2001 Ford Mustang V6-3.8L VIN 4
Vehicle > Technical Service Bulletins

DRIVELINE - WHINING NOISE ON COASTDOWN

01-10-8

1999-2001 MUSTANG

Figure 1

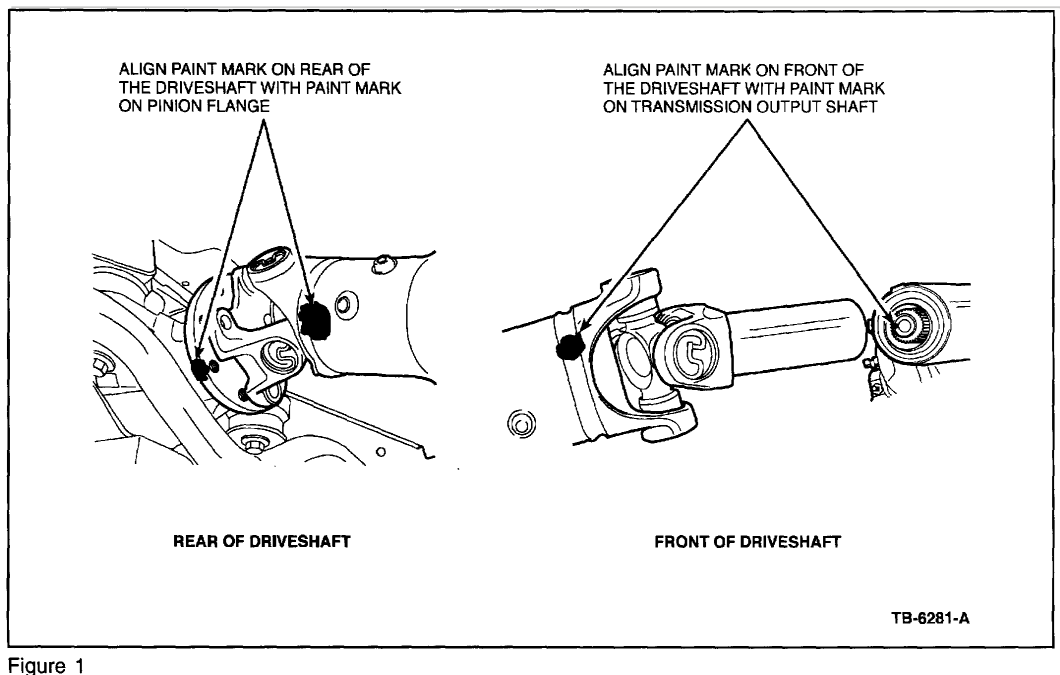
1. Raise vehicle on hoist. Using the appropriate year Mustang Workshop Manual, Section 205-01, replace the driveshaft. Refer to parts table for application listing. Make sure that the front driveshaft yellow paint dot is aligned with the paint dot at the end of the transmission output shaft (A/T only). Align the rear driveshaft yellow dot with the corresponding dot on the pinion flange (refer to Figure 1).

FAILURE TO PROPERLY INDEX THE DRIVESHAFT MAY RESULT IN A DRIVELINE VIBRATION.

Figure 2

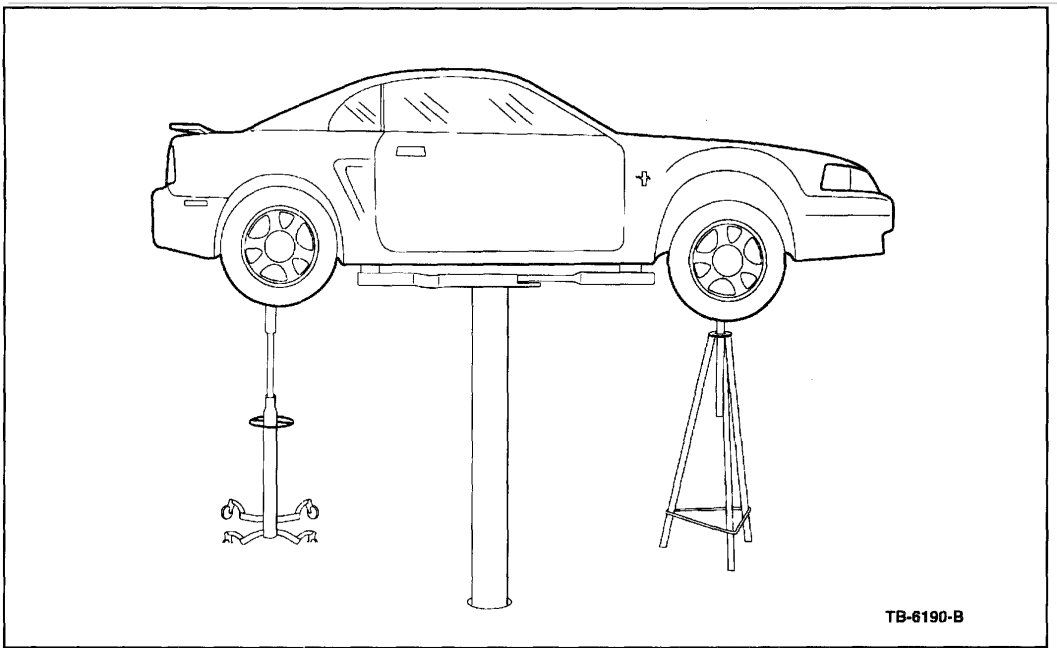
1. With vehicle still on hoist, place a tall screw-type jack stand at the front of vehicle under the front crossmember just below the steering gear. Adjust stand to make contact with the crossmember. Do not raise vehicle with the jack stand (refer to Figure 2).
2. Use an automatic transmission jack to raise the axle assembly as far as possible without raising the vehicle off the hoist (refer to Figure 2).

Figure 3

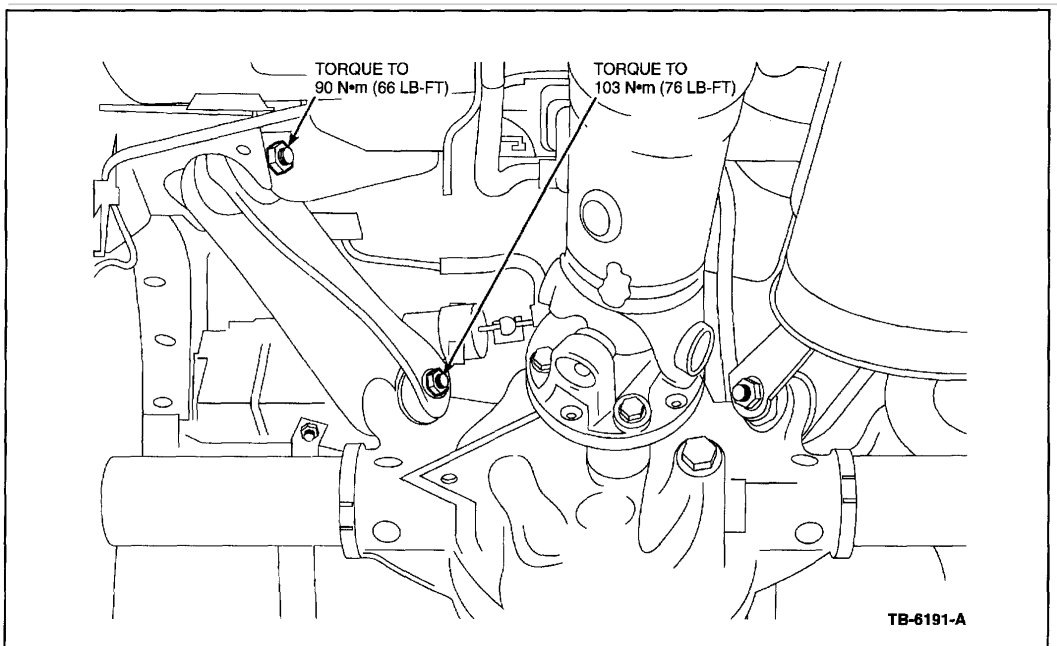
3. Torque the control arm bolts as follows (refer to Figure 3):

^ Two (2) upper arm-to-frame bolts to 90 Nm (66 lb-ft).

^ Two (2) upper arm-to-axle bolts to 103 Nm (76 lb-ft).

FAILURE TO NEUTRALIZE THE UPPER CONTROL ARM BUSHINGS MAY RESULT IN PREMATURE WEAR OF THE BUSHINGS AND EXCESSIVE TRANSFER OF AXLE NOISE INTO THE VEHICLE.
